REVISED RESPONSE TO REQUEST FOR ADDITIONAL INFORMATION

APR1400 Design Certification

RAI No.: 347-8435

SRP Section: 15.04.03 – Control Rod Misoperation (System Malfunction or Operator Error)

Figure 1. Time vs. Core Average Heat Flux (12-Finger CEA Drop)

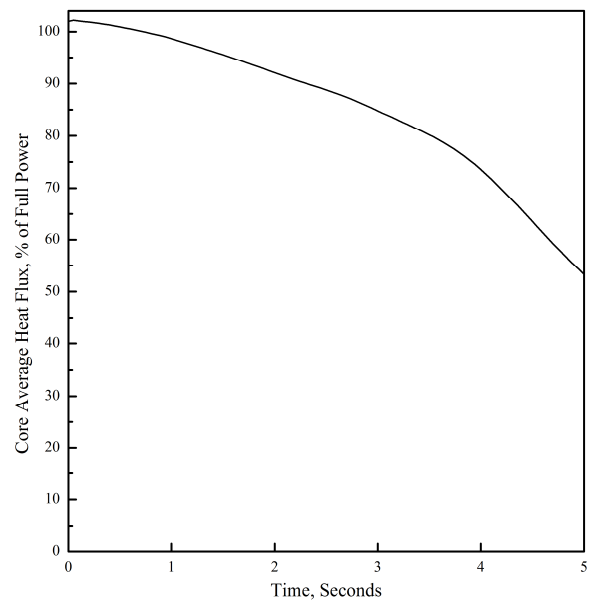
In addition, the audited calculation note indicates that, as of August 2012, the 12-finger CEA drop had not been evaluated but will be in future analyses for the core operating limiting supervisory system (COLSS) and the core protection calculator system (CPCS). The calculation note also states that, if a 12-finger CEA drops, the CPCS will appropriately generate a trip if it is necessary because the CPCS conservatively calculates DNBR every 0.05 seconds. The applicant has nevertheless provided no information on its analyses for 12-finger CEA drop events. Absent such information, the staff can neither assess the applicant's analyses for a range of 12-finger CEA drop events nor verify their implications, if any, for determining the limiting CEA drop event.

Please provide justification that the four-finger single CEA drop is the limiting event for DCD Section 15.4.3. A summary of analysis results using different rodged core configurations, dropped rod types and locations, and different cycle conditions would assist the reviewer in confirming that the event analyzed is the limiting event. Supporting information should include the basis for the maximum radial peak distortion factor of 1.205 as well as a summary of analyses performed for 12-finger CEA drop events.

Figure 1 and Figure 2 show the typical heat flux and DNBR behavior during the 12-finger CEA drop event. In this analysis, the 12-finger CEA drop occurs at 0 seconds and CPC generate reactor trip signal at 0.85 seconds including the processing delay time and reactor trip breaker opening time. And considering the holding coil decay time (0.5 seconds), scram rods begin to drop into the core at 1.35 seconds. Although the DNBR is decreased due to the static Fr distortion within 1 second, the DNBR begins to increase in combination with heat flux decrease by 12-finger CEA drop. After that, the minimum DNBR is maintained above the DNB SAFDL by CPC trip.
